NOTICE OF DECISION

DATE OF NOTICE:	March 29, 2018
DATE OF DECISION:	March 28, 2018
FILE:	ZC-01-17; CU-10-17; SP-08-17: and LA-02-17
TYPE OF APPLICATIONS:	<ol style="list-style-type: none">1) Zoning Map Amendment (Type IV-Q) to change 19.21 acres of Industrial Park (IP) zoning to Light Industrial (LI);2) Conditional Use Review application for new construction of a School District Bus Transportation Facility and related site improvements;3) Site Plan Review application for new construction of a Self-Serve Storage Facility; and4) Property Line Adjustment to relocate a property line to accommodate construction of the School District Bus Transportation Facility.
REVIEW BODY:	Planning Commission and City Council
PROPERTY OWNERS/APPLICANTS:	<ol style="list-style-type: none">1) Greater Albany Public School District; Russell P. Allen, Director of Business and Operations; 718 7th Avenue SW; Albany, OR 97321-2320 (Tax Lots 700 & 1103)2) Glorietta Bay LLC; Scott D. Lepman, President; 100 Ferry Street NW; Albany, OR 97321 (Tax Lot 501)3) Phyllis I. Perlenfein Trust; 3620 Columbus Street SE; Albany, OR 97322-6180 (Tax Lot 1105)4) Loren and Marge Lottis Trust; 2743 Front Street NE; Salem, OR 973

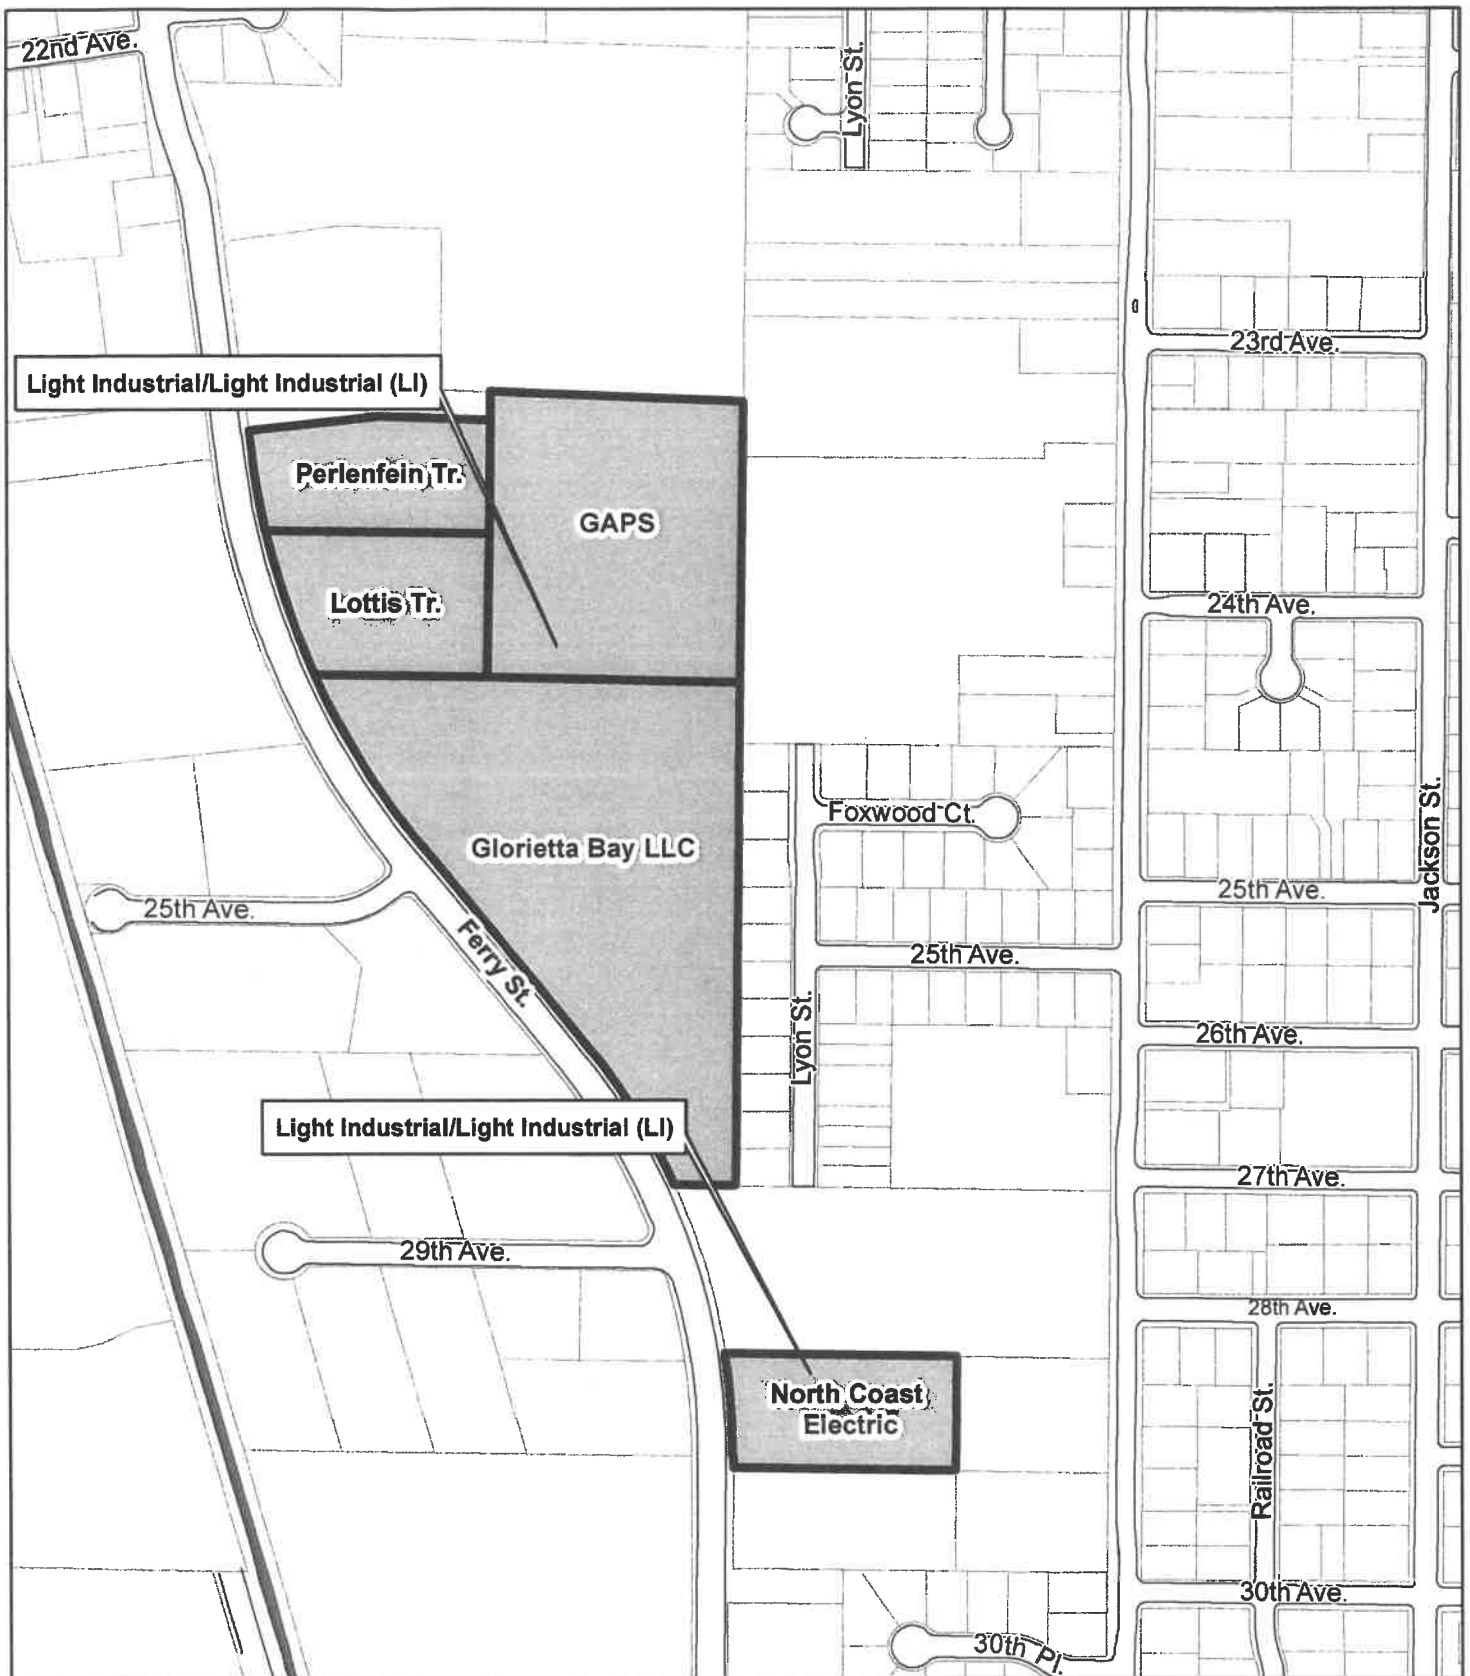
- a. Fire hydrant location: All portions of buildings constructed or moved into the City shall be located within 400 feet (600 feet for fire sprinkler-protected buildings) of a fire hydrant located on a fire apparatus access road using an approved route of travel. (OFC 508.5.1)
- b. Required hydrants based on the required fire flow as calculated in accordance with OFC 503.7 and OFC Appendix B. The minimum number of fire hydrants is determined by OFC Table C105.1.

OFC Table C105.1 identifies that at least eight (8) compliant fire hydrants are required for this project based on an estimated fire flow demand of 8,000 gpm; however, additional fire

hydrants may be required based on other criteria. If fire sprinklered, a minimum of two (2) fire hydrants will be required.
